EL PASO COUNTY GRADING AND EROSION CONTROL PLAN CHECKLIST

SPACE VILLAGE FILING NO. 4
A PORTION OF THE NW 1/4 OF SEC. 17, T14S,
R65W, OF THE 6th P.M., EL PASO COUNTY, COLORADO
GRADING & EROSION CONTROL PLAN

SPACE VILLAGE FILING NO. 4
EL PASO COUNTY, CO

Know what's below.
Call before you dig.

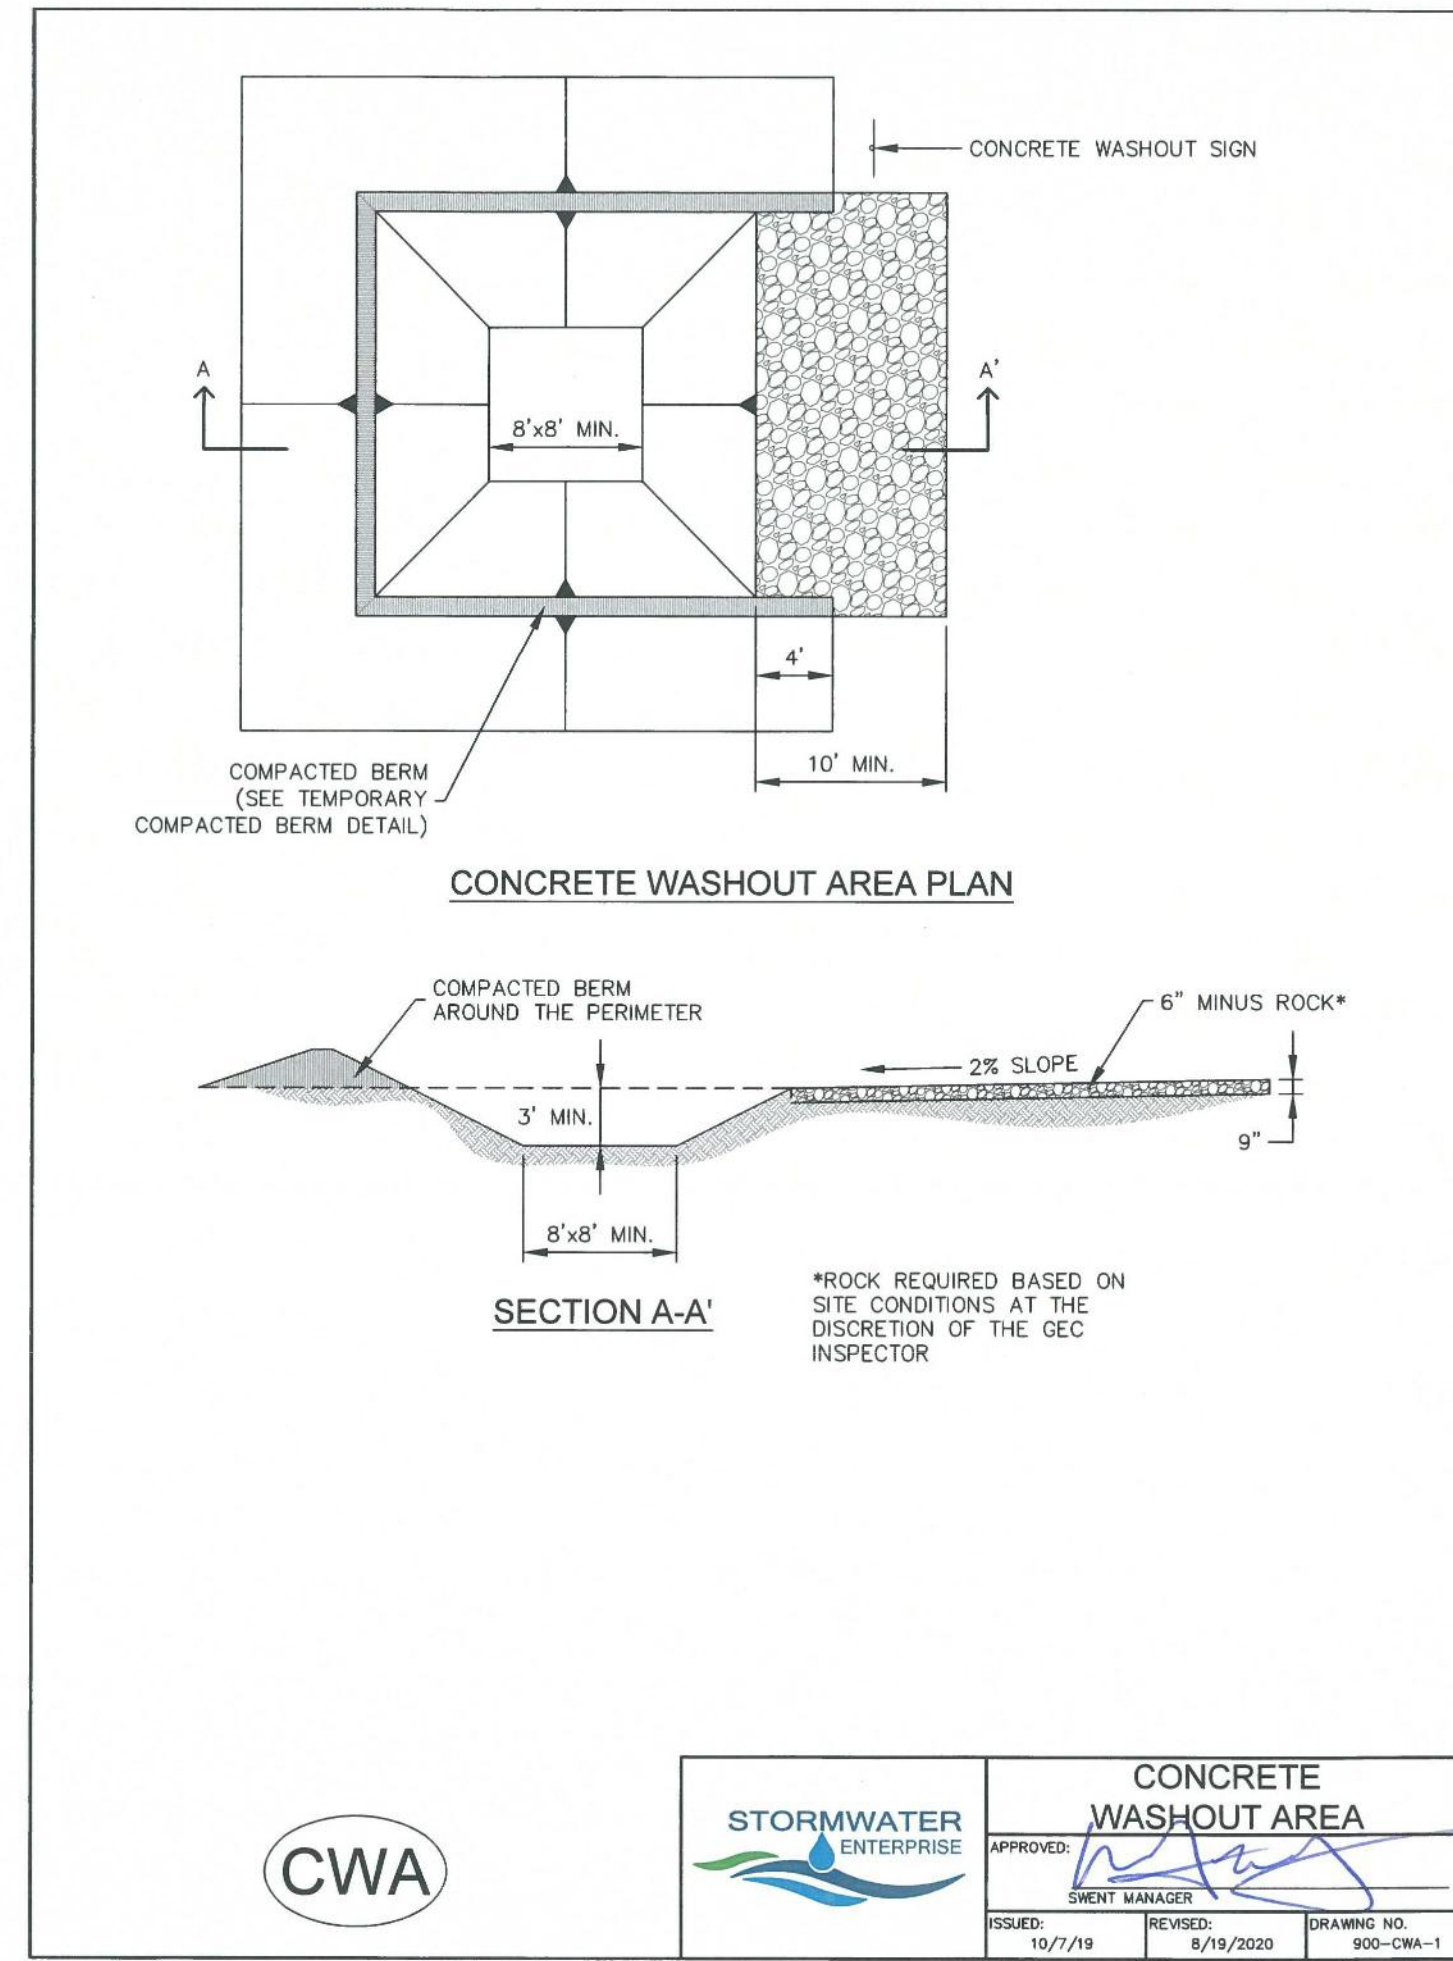
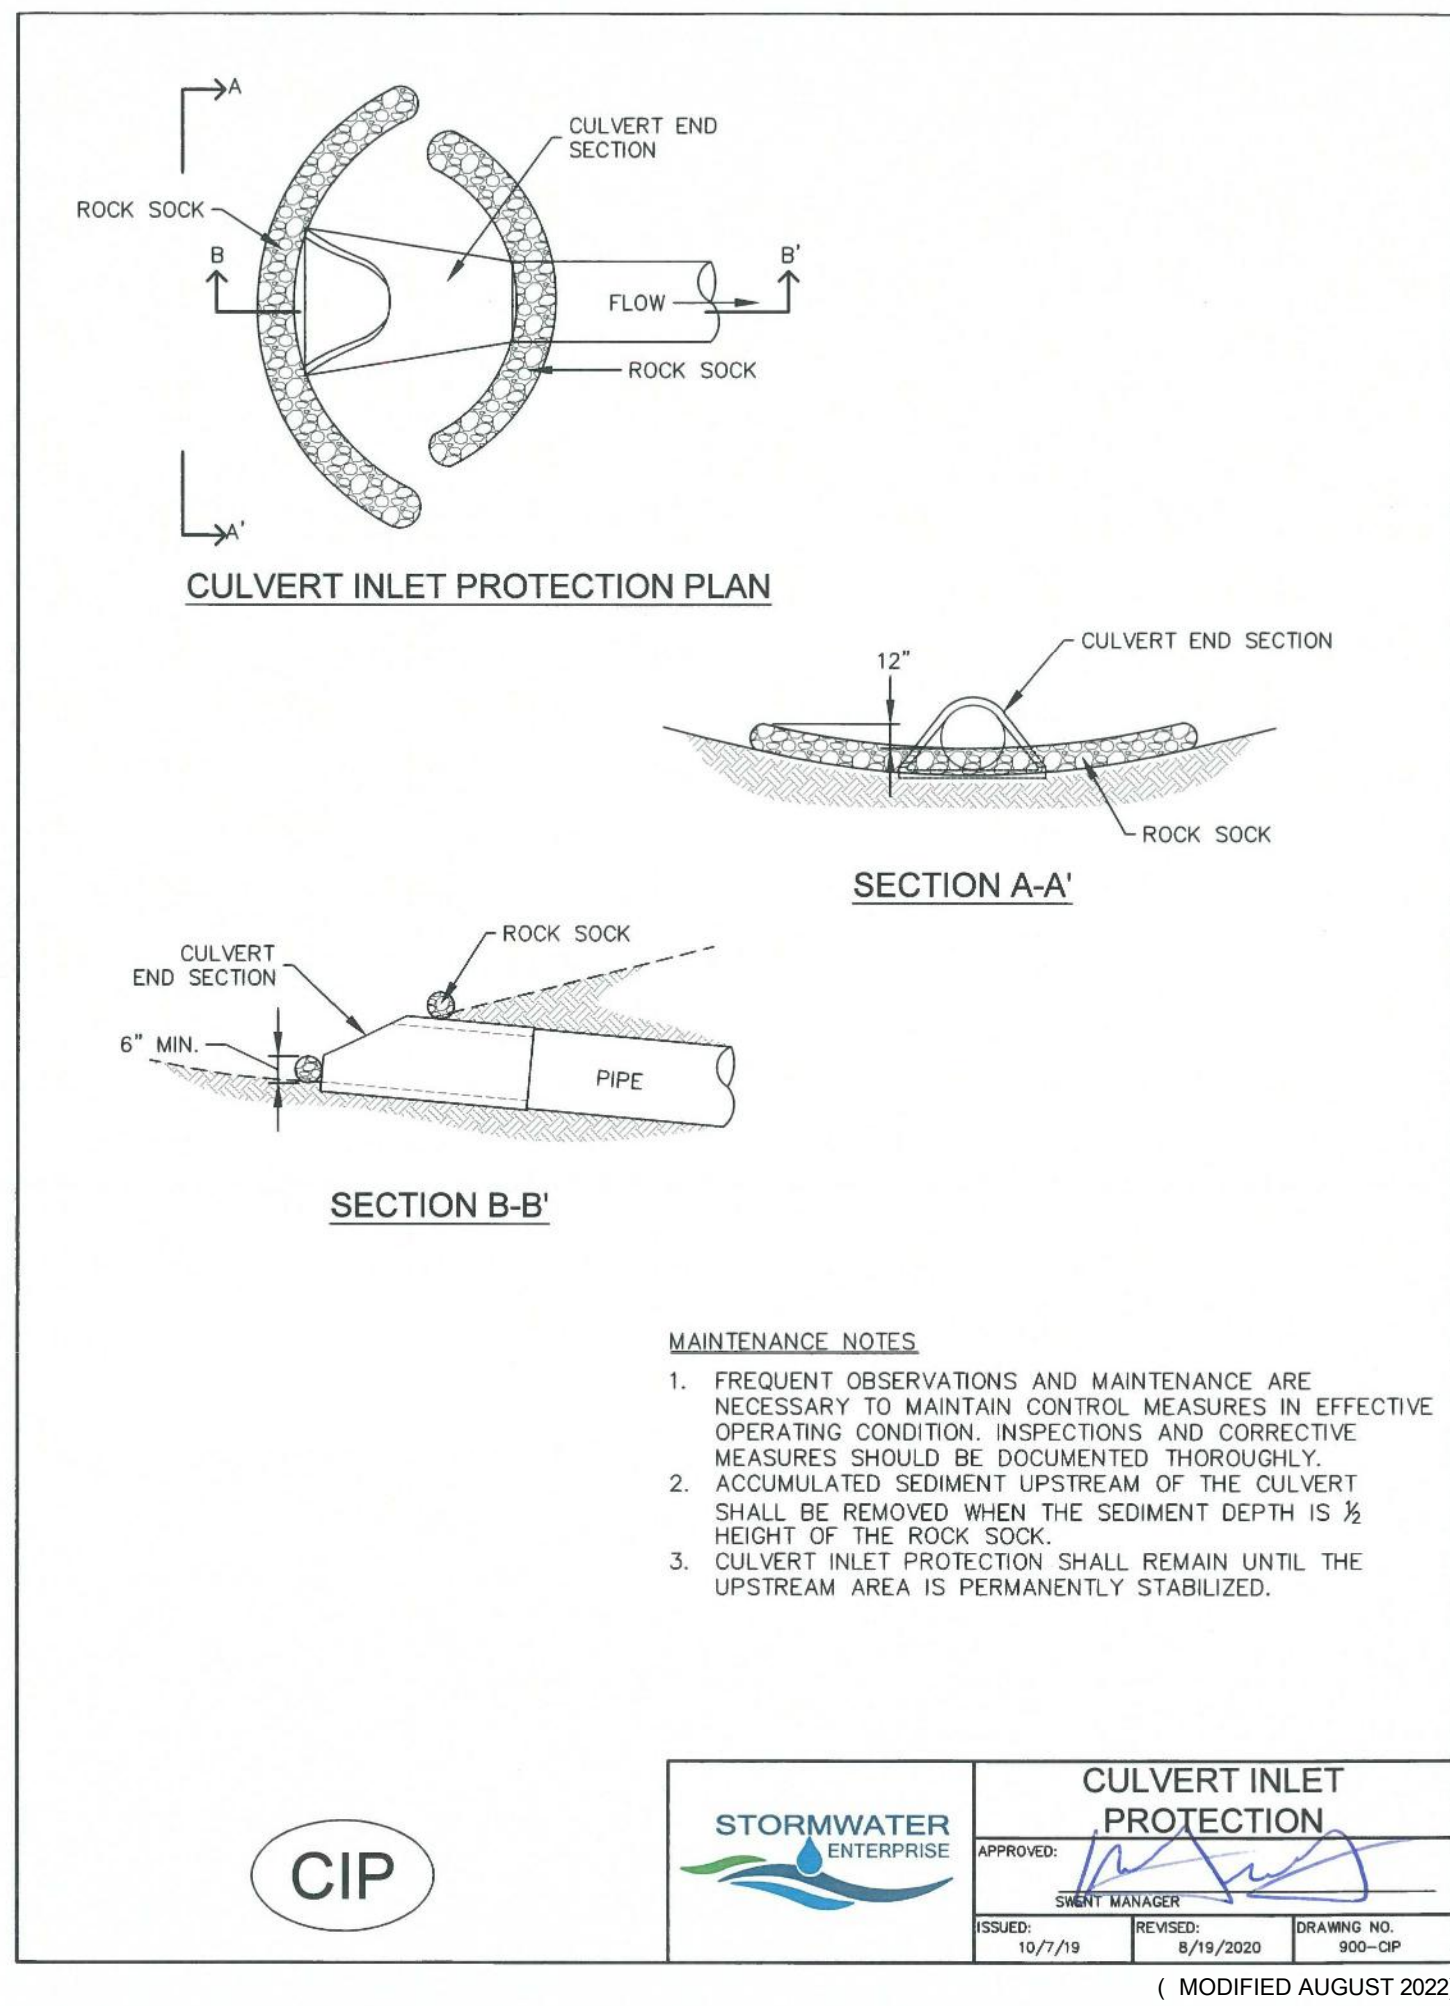
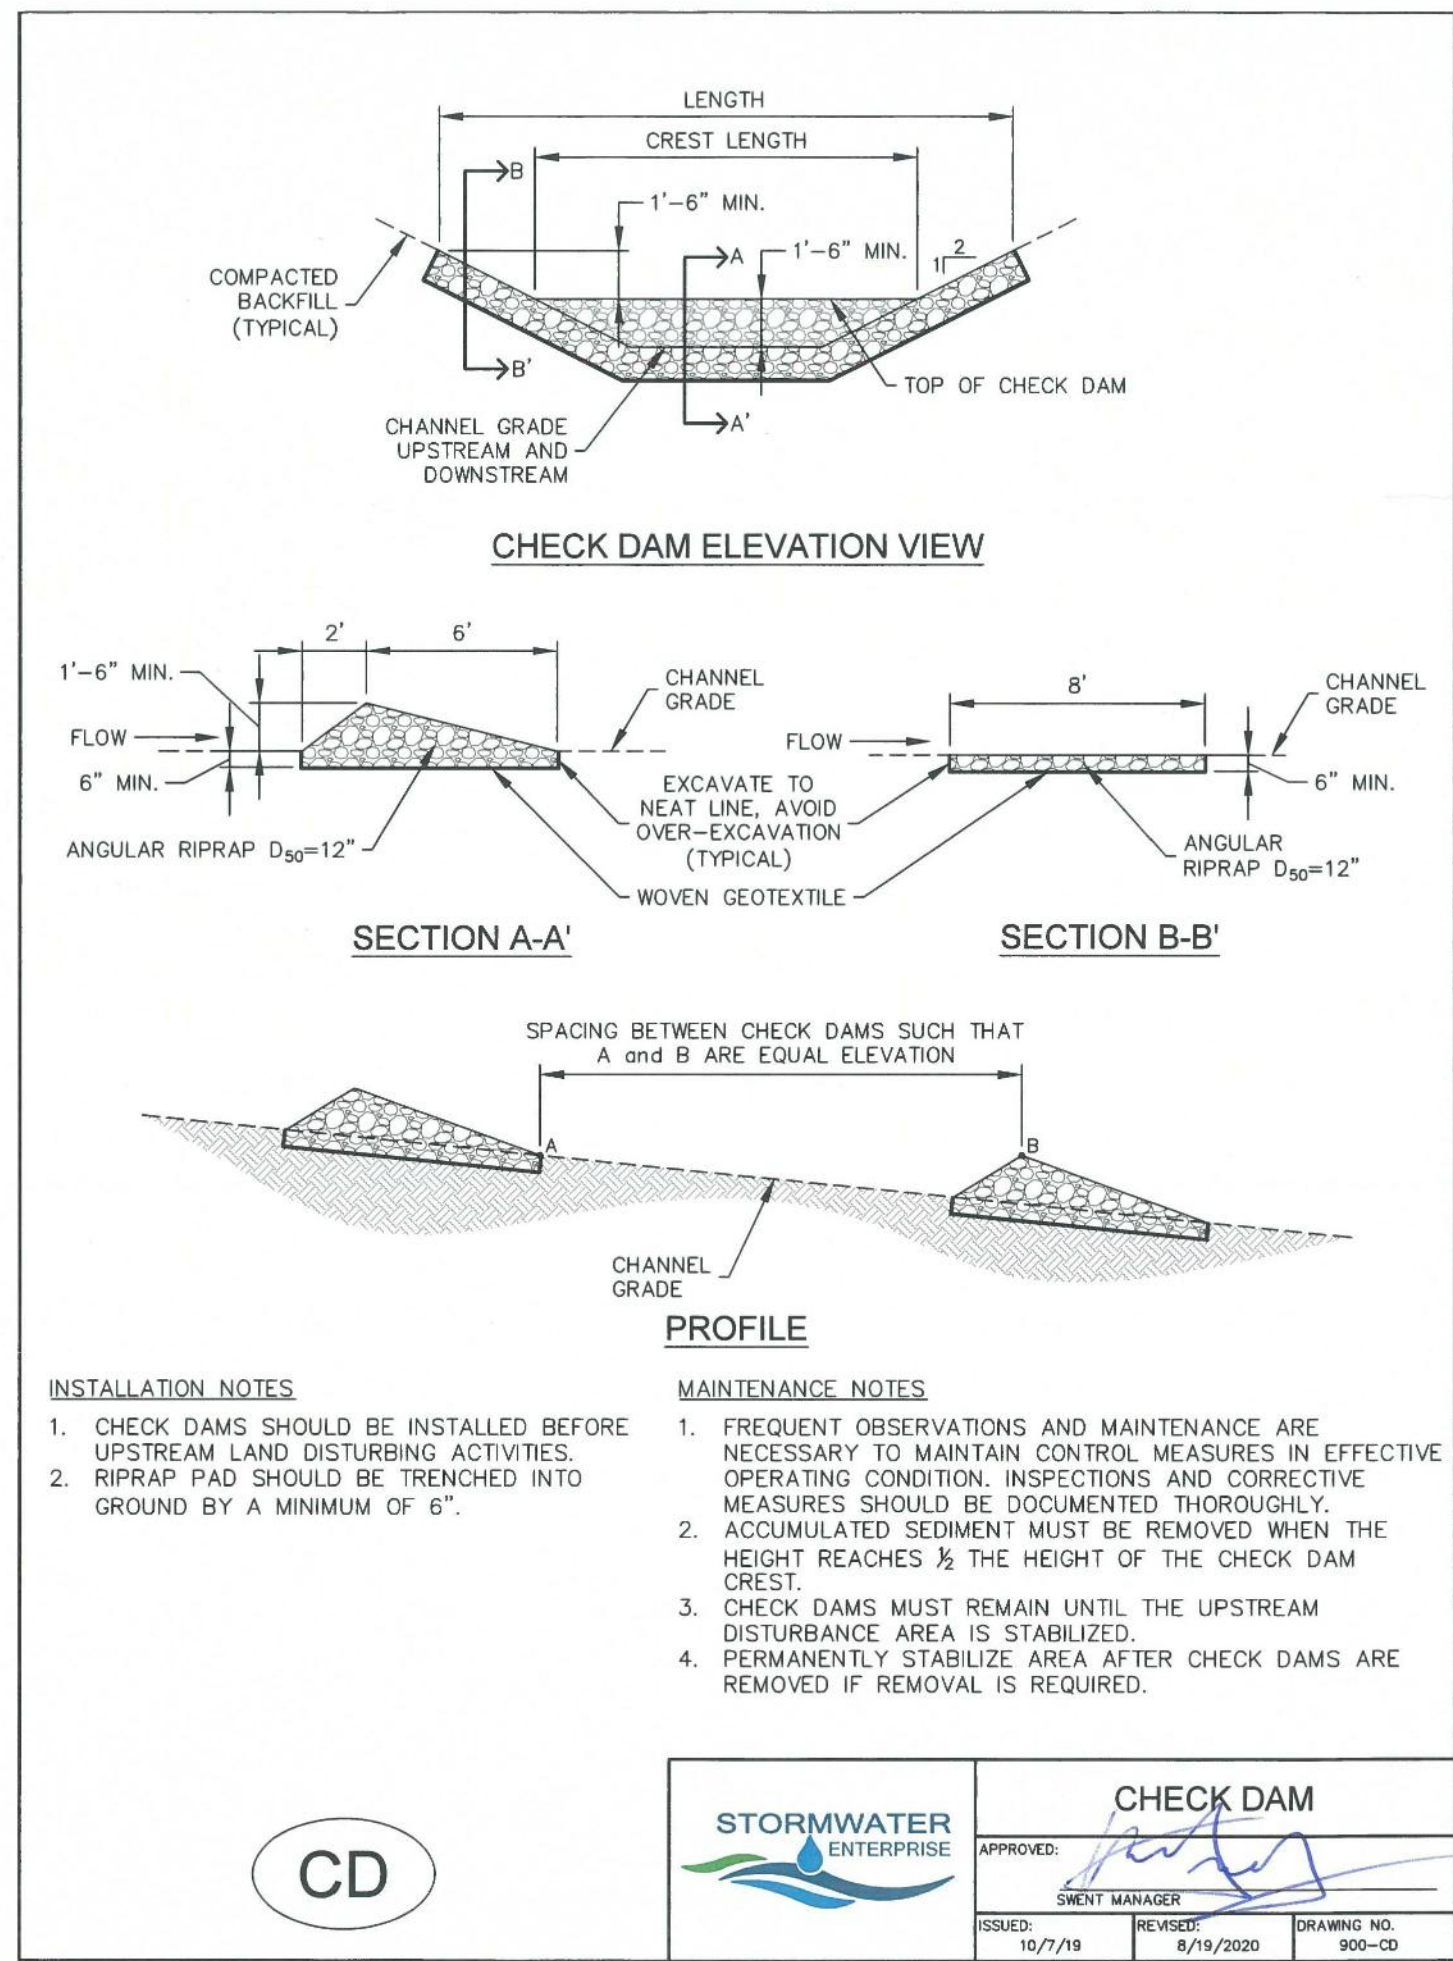
Sediment Traps are not appropriate for treating tributary areas >1ac. A Sediment Basin is for areas >1ac. Add a detail on final pages for Sediment Basin too.

Provide details for pond. To expedite the review process, I have preemptively provided our most common review comments on pond plans and details for you to consider when preparing the details:

- Emergency Spillway: provide bedding material/geotextile fabric between riprap and sub-base (per DCMv1 - Chap 10.10.5). Does not apply to spillways using soil riprap.

- Maintenance Roadway: Stabilized access ramp shall be a minimum of 15ft wide and no greater than 12% slope, in accordance with DCMv1, Chap 11.2.2. Provide roadway detail/cross section, including stone sizing and gradation. Consider using a base course that will minimize migration of fines when the pond is detaining water.

- Outlet Pipe: Per DCMv2 Section 4.3, outlet pipe should be 18" minimum.
- Pond Bottom: Pond bottom should have a minimum slope of 3% to the trickle channel and micropool (USDCM Vol 3, detail T-5). Please adjust to minimize future maintenance needs.

- Trash Rack: Trash rack to be Amico Klemp KRP Series aluminum bar grate (Figure 6-b), US Filter or Johnson stainless steel well screen with #93 VEE wire (Figure 6-a), or equivalent (per EPC DCMv2, Chap 4.3 and MHFD Detail T-12).

GEC Checklist Items H and M. If "limits of disturbance" and "construction boundary" are the same, change to "limits of construction/disturbance" or otherwise show as separate line types for each on the legend and figure.

DIVERSION SWALE
NOT TO SCALE

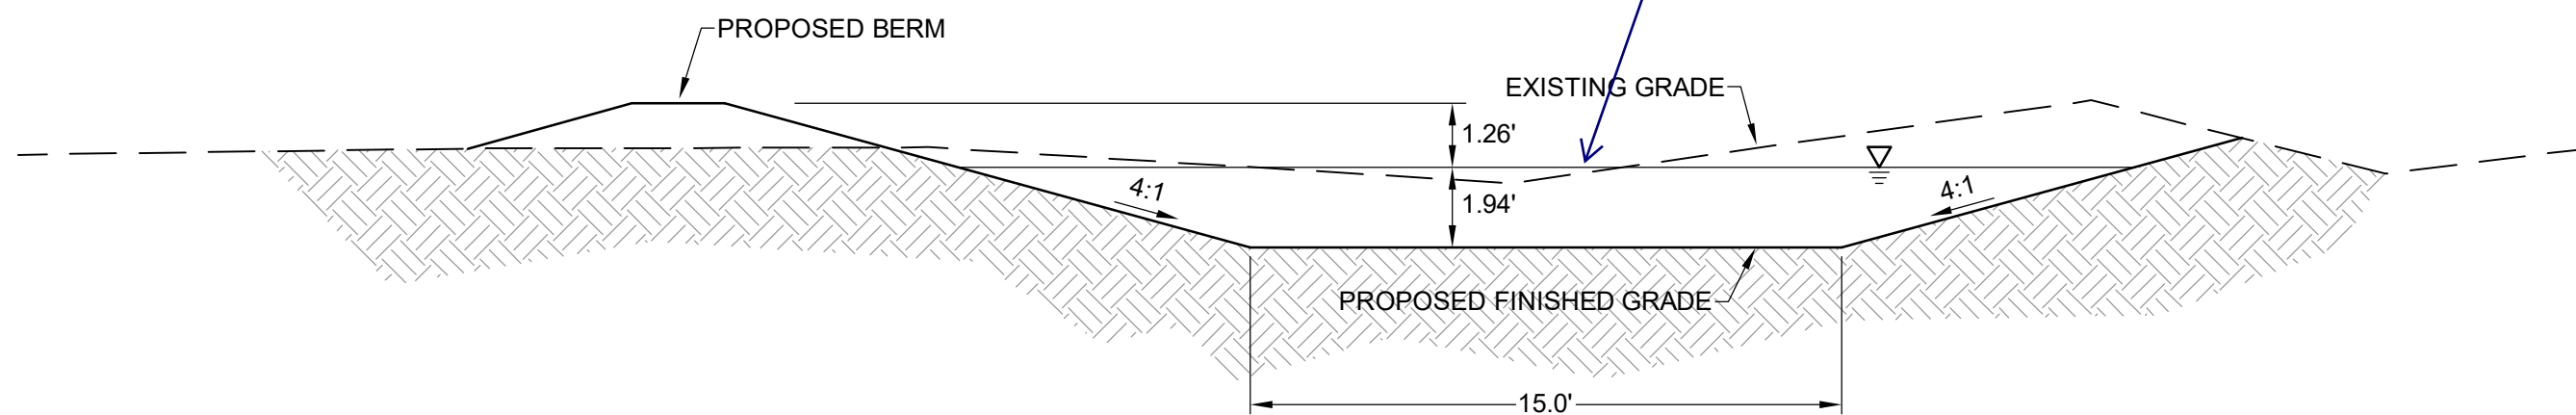
provide top width
distance
